**RESPONSE TO REQUEST FOR ADDITIONAL INFORMATION**

**SAFETY SYSTEM DIGITAL PLATFORM  
- MELTAC (MITSUBISHI ELECTRIC TOTAL ADVANCED CONTROLLER) -  
TOPICAL REPORT**

**Mitsubishi Electric Corporation**

**TAC NO.:** MF4228  
**RAI NO.:** #1  
**DATE OF RAI ISSUE:** 6/29/2016

Figure 1 Failure detection capability for maintenance bypass

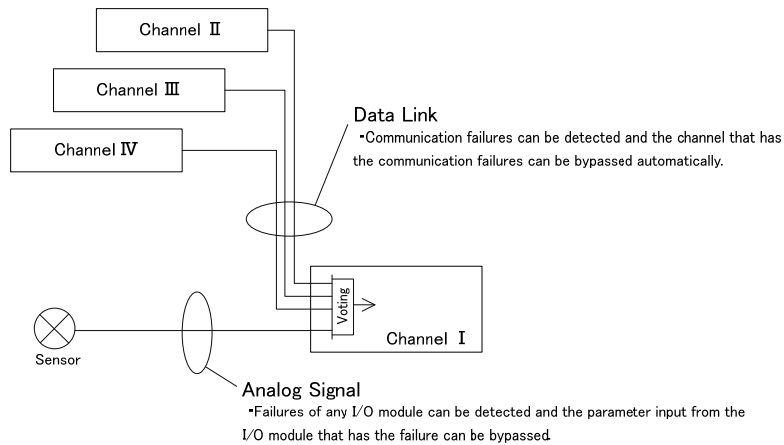
Page 12, Table 3, IEEE 603, 6.6 & 6.7, Operating and Maintenance Bypasses. Confirm for the NRC staff that the generic platform has the capability to complete these two requirements. It is understood by the NRC staff that specific operating bypasses are defined on a plant specific basis as well as plant specific Technical Specifications govern the use of the maintenance bypass feature.

The MELTAC platform also provides the capability to automatically initiate maintenance bypasses for self-detected failure condition. For example, the MELTAC platform has the capability for detecting communication failures, as described in JEXU-1041-1015, "MELTAC Platform ISG-04 Conformance Analysis". When any communication error is detected, the affected measurement channel(s) can be bypassed automatically. In addition, the MELTAC platform has the capability for detecting analog input failures, as described in Section 4.1.5.5.1 of JEXU-1041-1008, "Safety System Digital Platform - MELTAC - Topical Report". When an I/O module failure is detected, the affected measurement channel can be bypassed automatically.

Figure 1 shows the failure detection capability of the MELTAC platform for automatic maintenance bypass in a typical system configuration. Any automatic maintenance bypass is subject to any application interlocks that may prohibit the automatic maintenance bypass if a channel from another division is already bypassed.
